SPARS NEW YORK REGIONAL MEETING

REVIEW : "PROBLEMS AND SOLUTIONS / AMPEX 1200"
SPEAKER: MICHAEL GUTHRIE, DIRECTOR OF ENGINEERING
RECORD PLANT STUDIOS, LTD. -NYC

Record Plant Studios MM-1200 modification procedures:

CHANGES AND ADDITIONS TO TAKEUP TENSION CONTROLLER KIT * Record Plant Studios
2/16/81

TRANSPORT CONTROL BOX SUPPORT SHELF
NEW HOLES LAYOUT

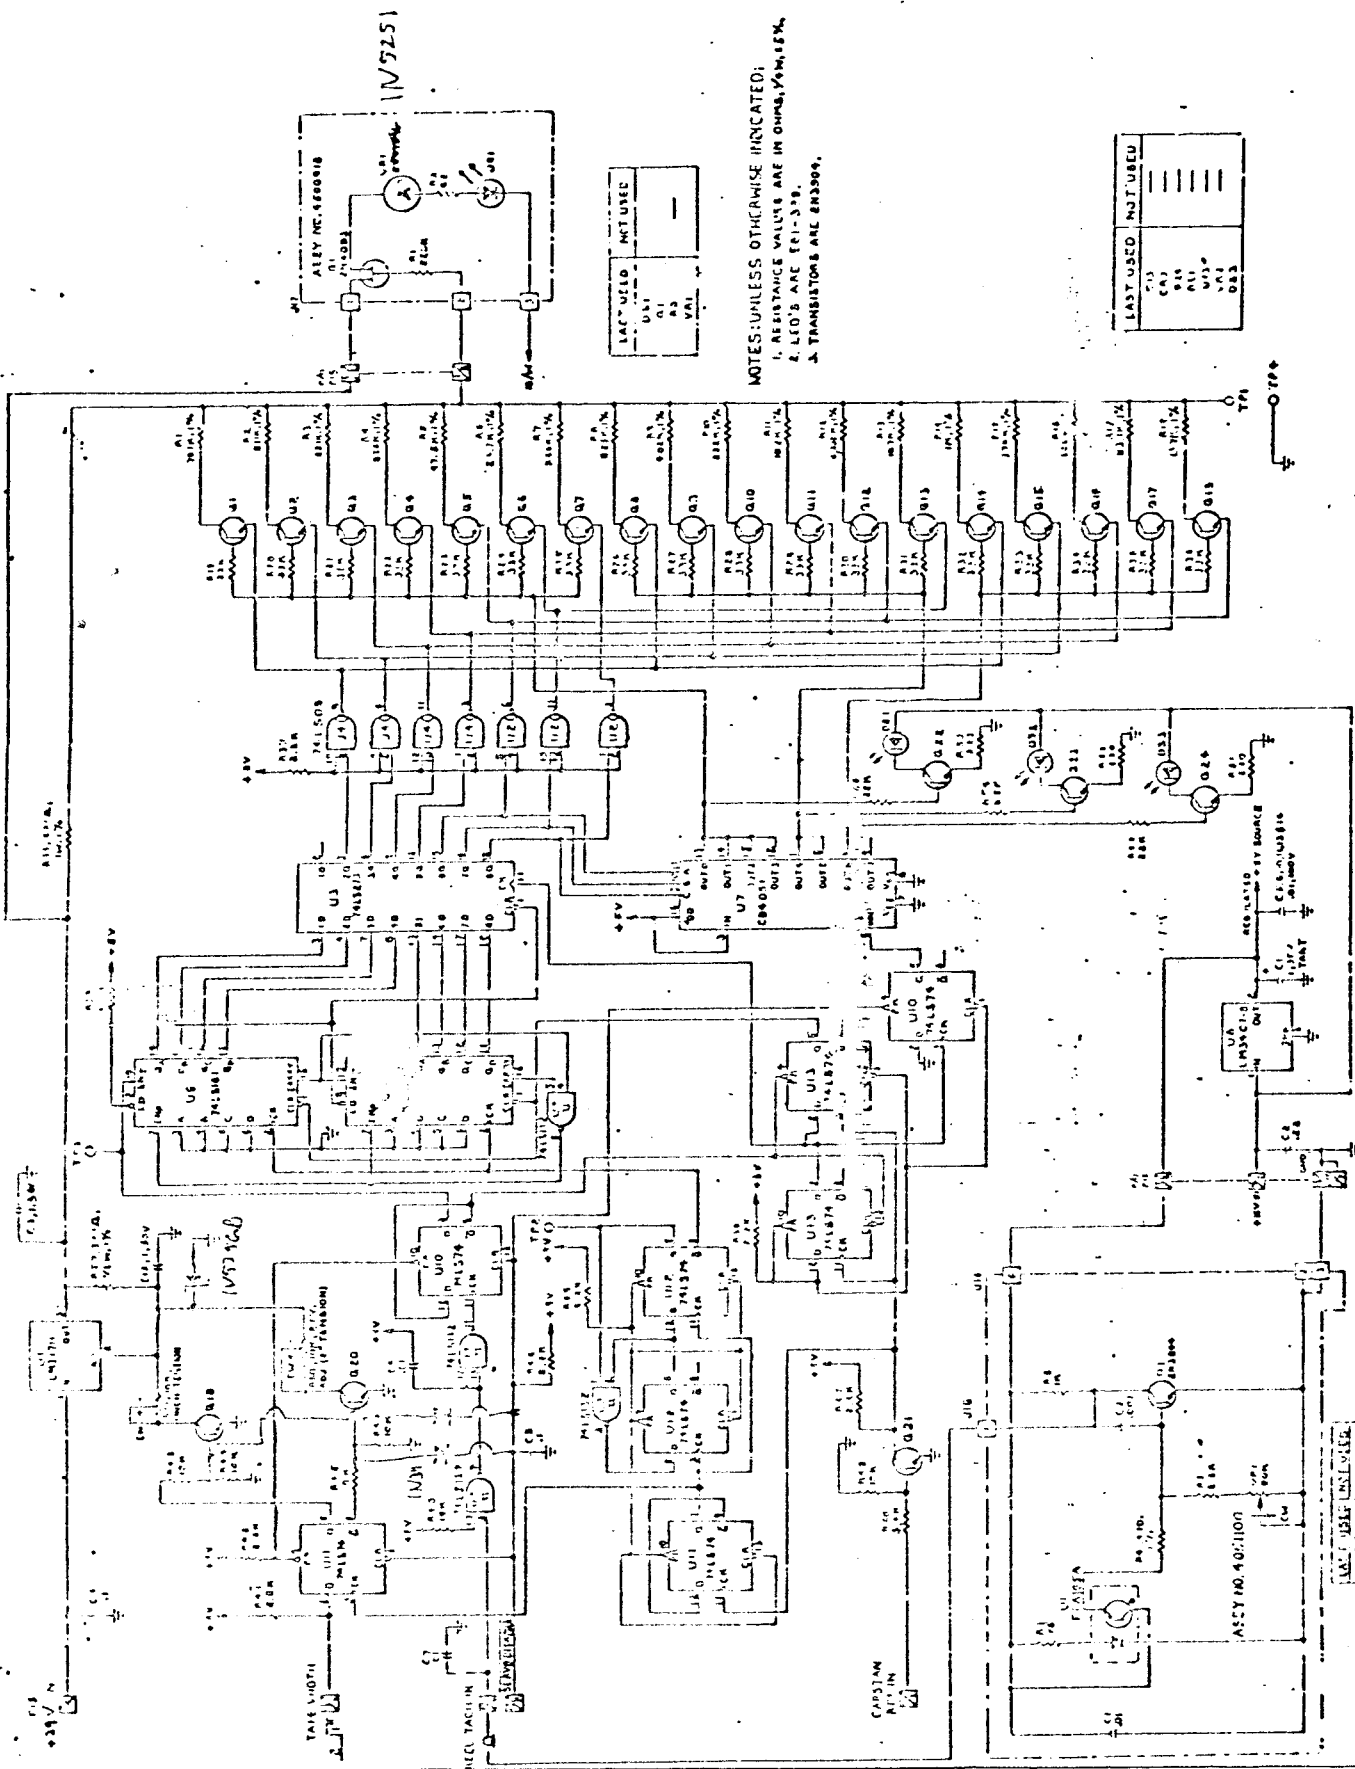
Note dimension change on hole location. This prevents interference between meter wiring and Tension controller PWA.

4.5 DRILL TWO HOLES 0.2 INCHES IN DIA. ON A LINE 0.62 INCHES FROM THE FRONT EDGE OF THE SHELF. THE HOLES ARE 5.2 INCHES APART AND THE FIRST HOLE IS 2.5 INCHES FROM THE LEFT EDGE OF THE SHELF.
